Cavanaugh Drive - Approach Reconstruction
2005

DATE	1-24-05	JOB NO.
ATTENTION		
RE:	Addison Airport	
	Cavanaugh Drive Approach	
	Reconstruction

To: Site Concrete
From: Town of Addison
Subject: Work Order CAV-1:

Date: May 19, 2004

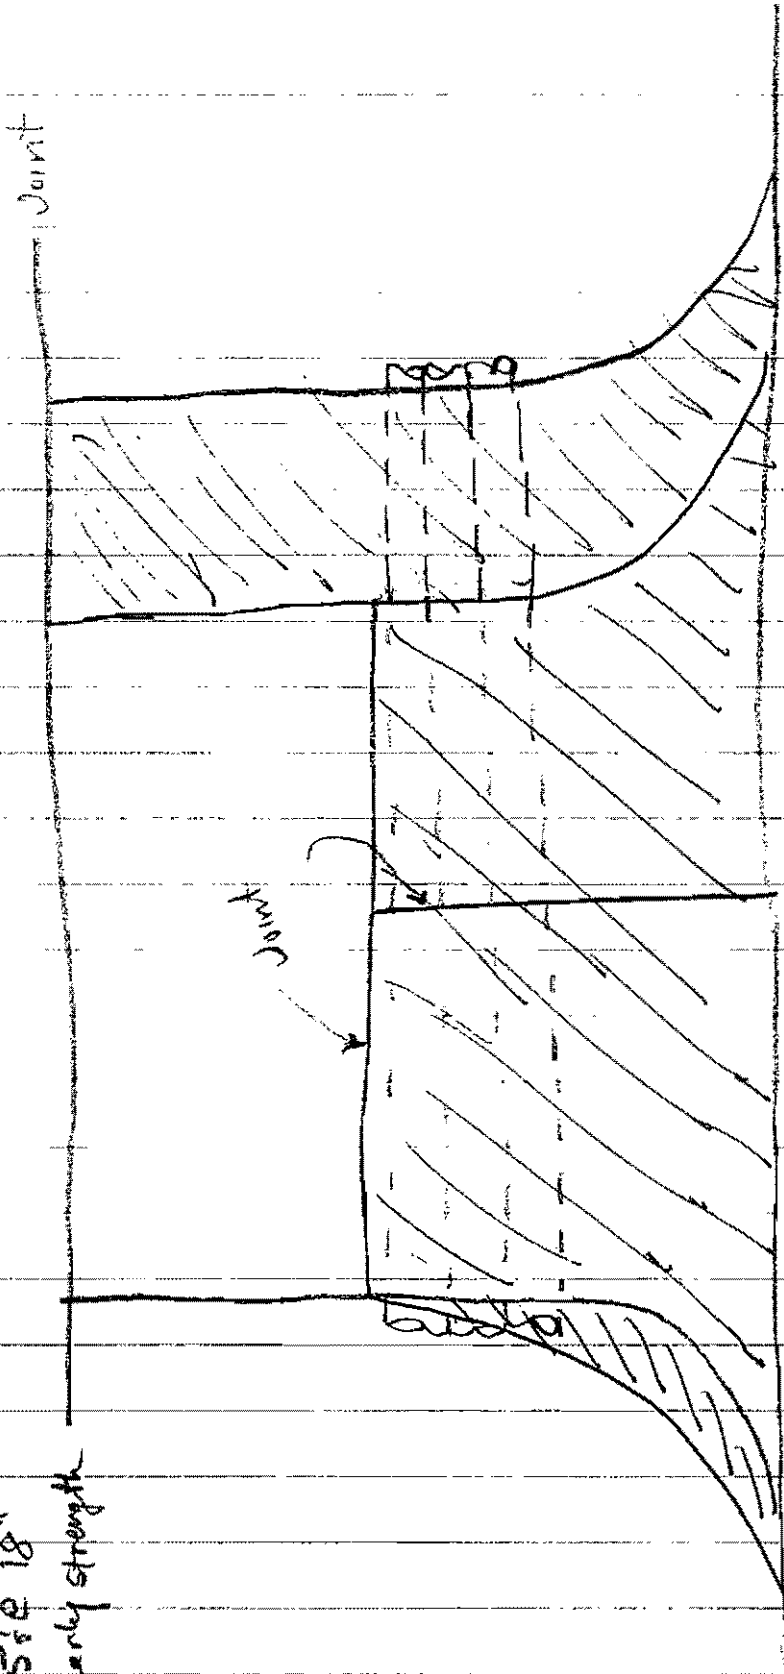
concrete to be added

- ① Remove concrete
- ② Relay Pipes — use any good existing, replace those needing replacement
- ③ Relay pipes with 1 foot space between each pipe
- ④ Backfill with flowable fill
- ⑤ Reinf # 5 @ 18"
- ⑥ use hi-early strength concrete

concrete to be removed

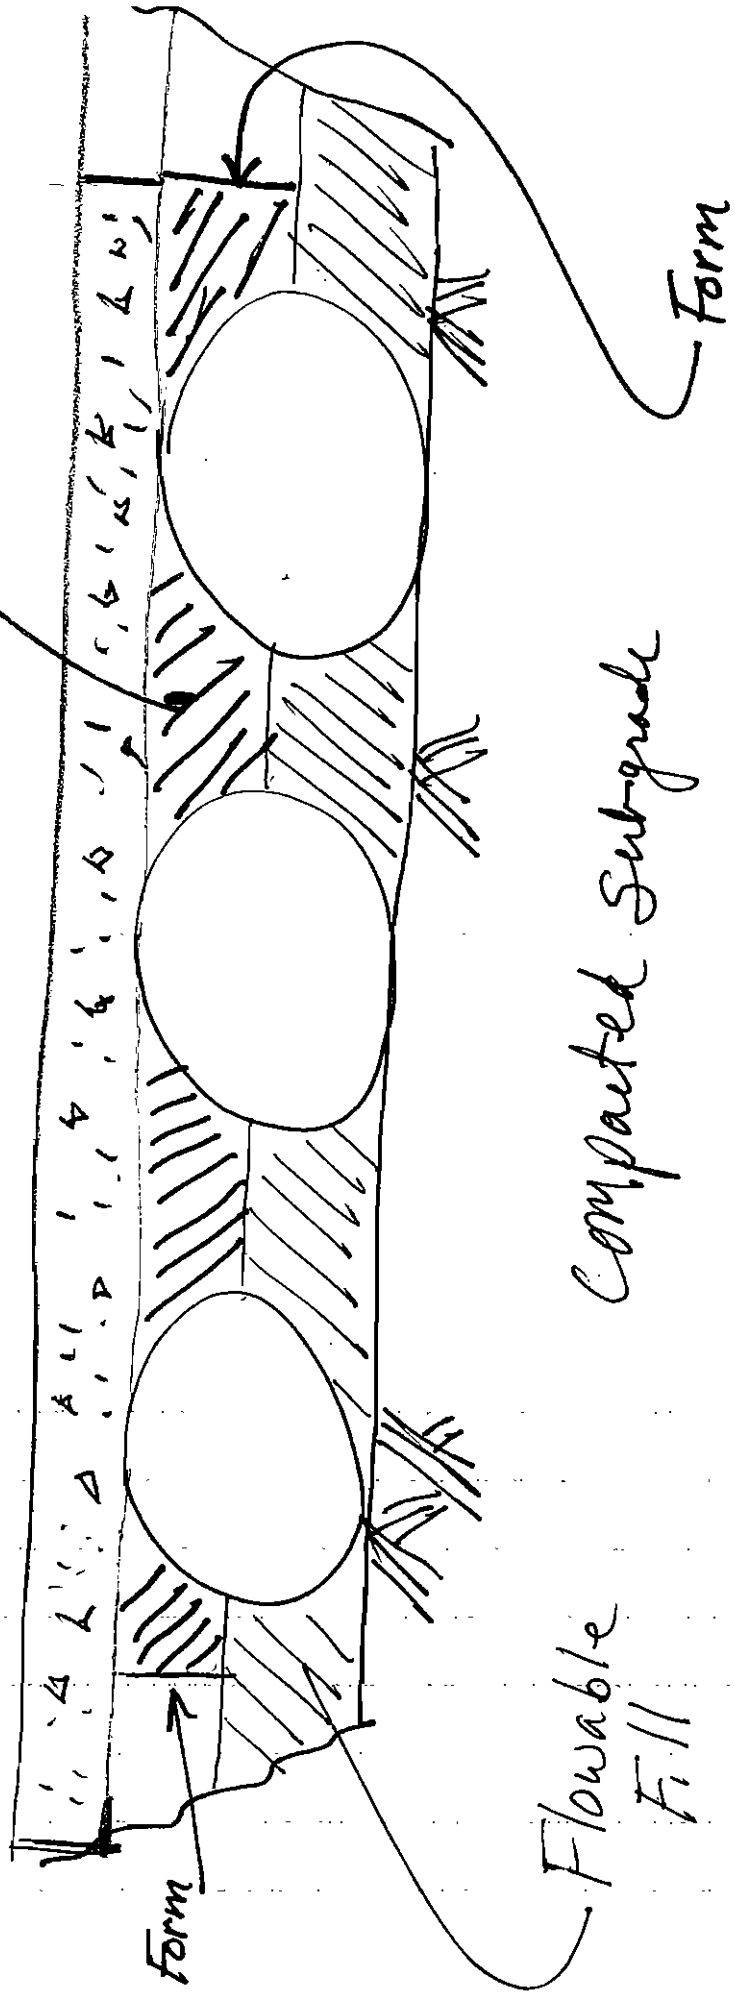
Well pipe float?

$$A = 785 \times \left(\frac{32}{12}\right)^2 = 785 \times 7.11 = 5.58 \text{ ft}^2, \quad \frac{1}{2} \times 2 = 2.79 \text{ ft}^2$$

$$2.79 \text{ ft}^2 \times 150 \text{ lb/ft}^3 = 418 \text{ lb}$$

Pipe weighs 366 lb/ft
Pipe and float
UMC Cradle
